RE: KISD Bursey Road – SP-15-0002, UDC-15-0002, P-15-0001
Keller ISD New Career & Technology Center
201 Bursey Road, Keller, Texas 76248

Requests for variances to landscape requirements:

KELLER ISD NEW C.T.E. HIGH SCHOOL
LANDSCAPE VARIANCE 7/21/17 SCALE: 1" = 30'-0"

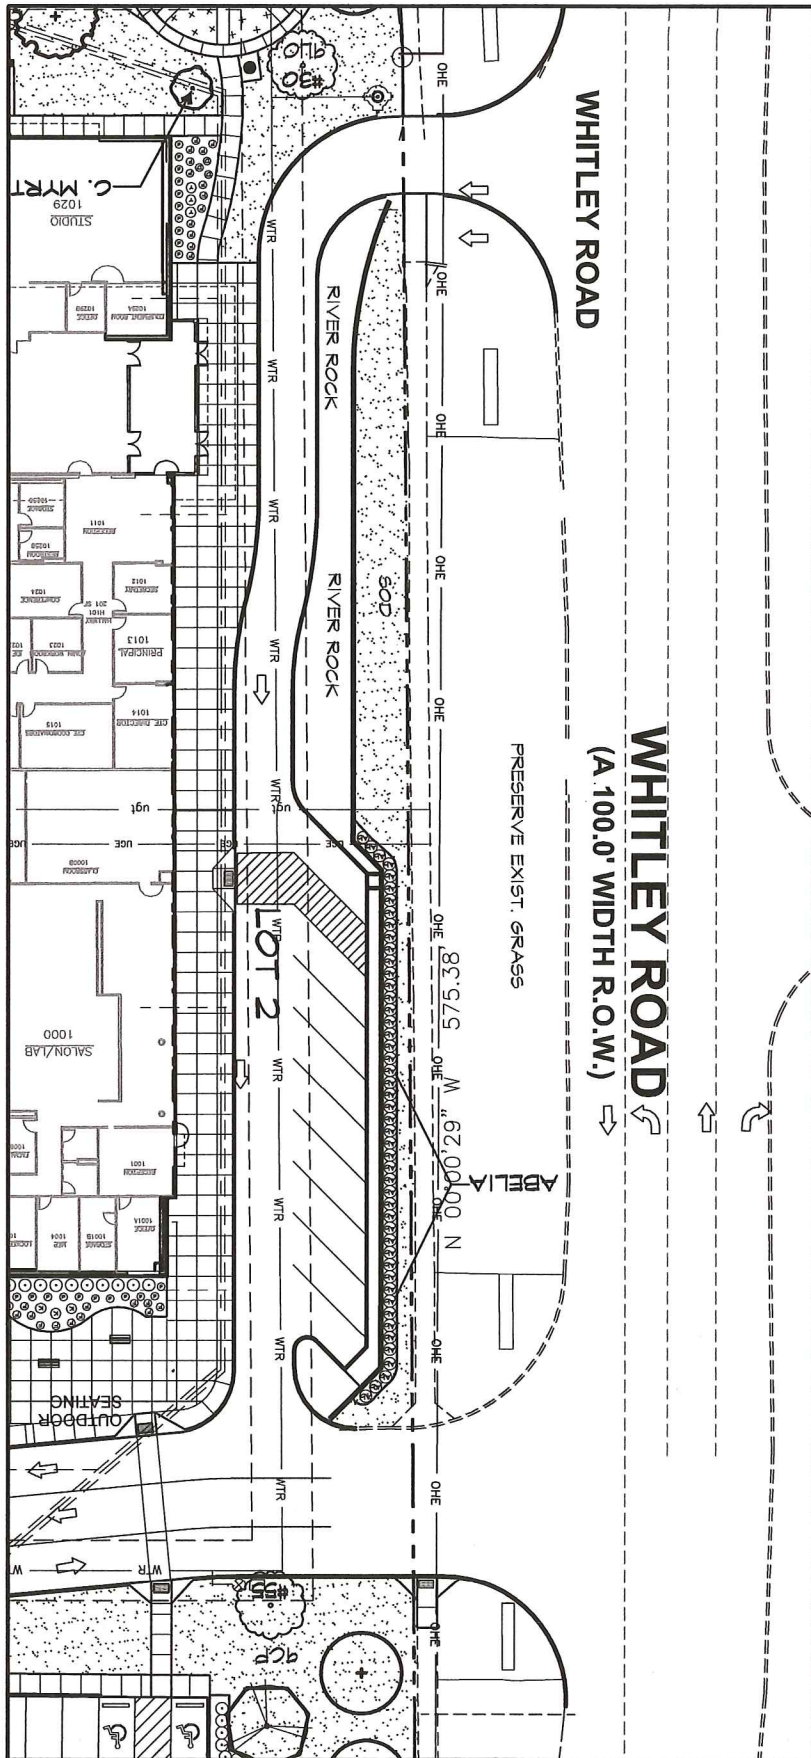
Section 9.03 (F.2.c) Buffer trees not installed due to proximity of power lines.

There are powerlines in close proximity to required tree buffer planting area along Whitley Road. We request that the 13 required trees for this area between the two entry drives be removed from the quantity of required trees.

+/-48 - 5 gallon Abelia shrubs have been planted at the base of a portion of the retaining wall along Whitley Road. The existing turf in this area is fully established. The existing irrigation system will not support additional shrubs without significant expense to bring new irrigation wires into the area.
